DATE: 03.21.2019
TO: ProTrak
FROM: Mitesh Baxi
Traffic Engineering

■ ST MARK MAYFAIRE ENTRANCE [TRC Plan Rev #5]

PEDESTRIAN REFUGE ISLANDS:

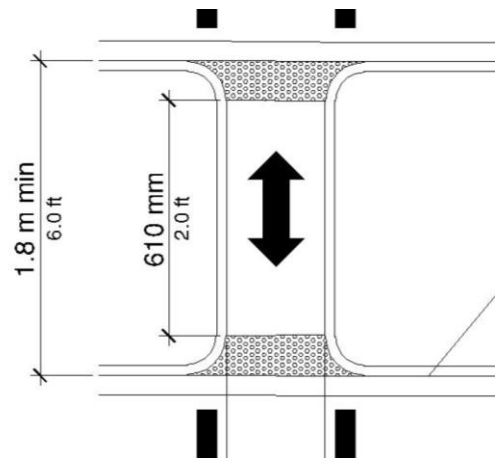
At cut-through pedestrian refuge islands, detectable warning surfaces shall be placed at the edges of the pedestrian island and shall be separated by a 2’ minimum length of surface without detectable warnings. On blended transitions, detectable warning surfaces shall be placed at the back of curb.

Left image from the site plan shows 7’ long island. Please verify and demonstrate with dimensions if this satisfies the condition as per right side image (only for the reference). Applicable to all the refuge islands.
